MEMORANDUM

Re: Rule 5.700 on Sound Levels from Wind Generation Facilities

Sheffield, Vermont

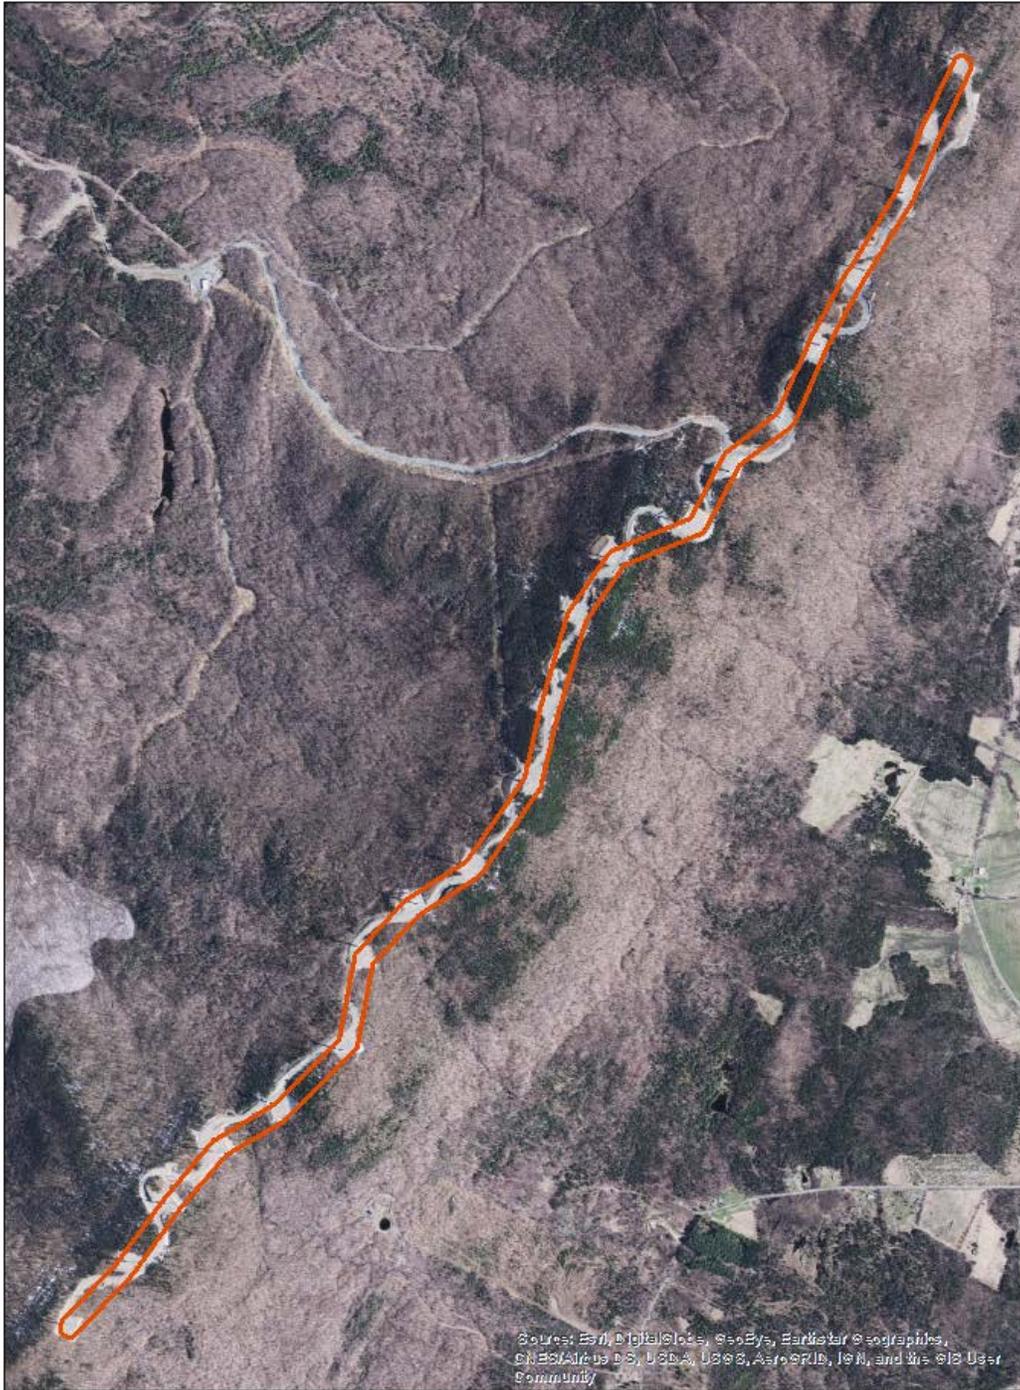
Moreover, it is critical to remember this land is the land available for the footprint of the turbines, as the setback would be measured from the turbines. The footprint of the turbines at the existing facilities is actually quite small. GIS software was used to calculate the footprint of the Sheffield, Lowell, and Georgia Mountain Projects (depicted on photos attached hereto) and is given below:

Sheffield=0.537 square miles
Lowell=0.122 square miles
Georgia Mountain=0.021 square miles

The 19.232 square miles is enough land for 36 Sheffields, 158 Lowells, or 916 Georgia Mountains.
